Re: Structural Observation — 913 South 13<sup>th</sup> Street, Erwin, NC 28339

#### DETERIORATED FRAMING AT THE FRONT-RIGHT LIVING ROOM

Living Room Framing Repair Plan

*Picture 2 – Deteriorated girder and ledger strip*

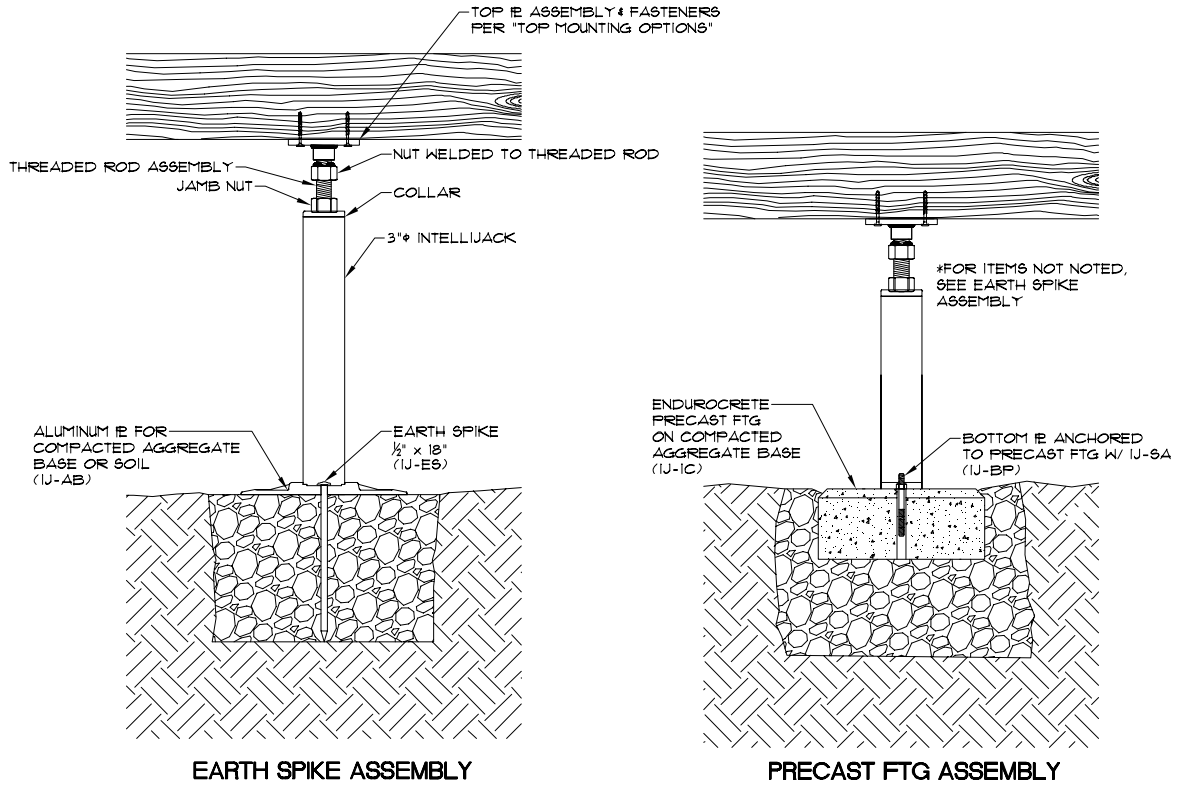
- Signs of moisture damage were noted throughout the first-floor framing system, particularly in the living room. Thorough probing indicated that the following framing members at the living room were deteriorated beyond salvageable limits:
  - The girder and ledger strip at 3<sup>rd</sup> span from the right along the front girder (*see picture 2*).
  - The leftmost (7) joists (*see picture 3 for example and attached repair schematic for reference*).
    - Most of these joists were noted to be improperly reinforced with non-continuous sister plies (*see picture 4 for example*).
  - Additional sections of the sill plate, rim band, and joists in the middle joist bay were deteriorated and/or cracked.

- 1) Remove the above-noted significantly deteriorated portion of the girder and replace using a new (3)2x10 #2 Southern Yellow Pine (SYP) material with continuous span between existing masonry girder support piers.

- a) Fasten joists to the sides of the new girder using Simpson face hangers.
- 2) Reinforce each of the deteriorated joists noted above with an additional full depth ply of 2x #2 SYP, fastened to the side of the deteriorated joists using (3)10d common nails at each end and at 12" on center staggered top and bottom along the lengths of the joists. Sistered material should span continuously between end supports.

Detail 1 – Intellijack Installation Specifications

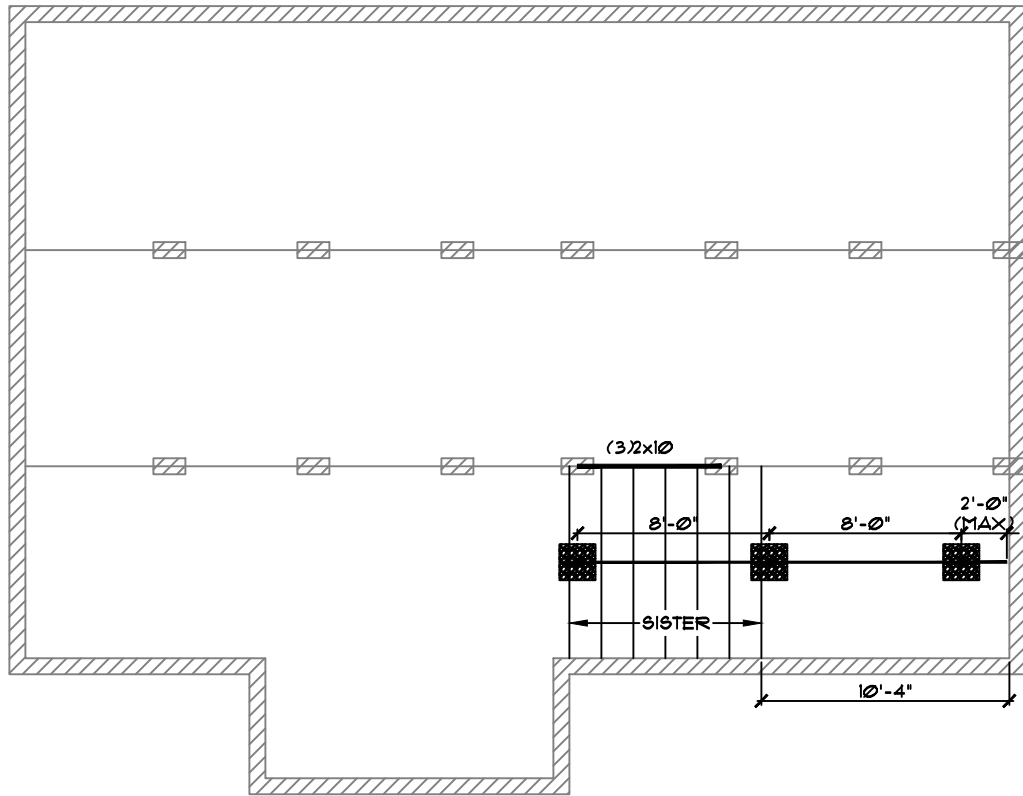
- 3) To provide additional reinforcement to the living room floors, install a supplemental S4x7.7 dropped girder within the middle  $\frac{1}{3}$  of the joists. The new girder should span from the right side of the home and extend to the left wall of the living room over IntelliJack supports on well-compacted 18"x18"x18" gravel footings spaced no more than 6'-6" apart. Girder ends may cantilever up to 2'-0" to avoid conflict with existing footings.

- a) If this beam is omitted from the final contract, the leftmost joist aligned beneath the left wall of the living room should still be reinforced with (2) additional plies and an IntelliJack support at mid-span installed per these specifications.
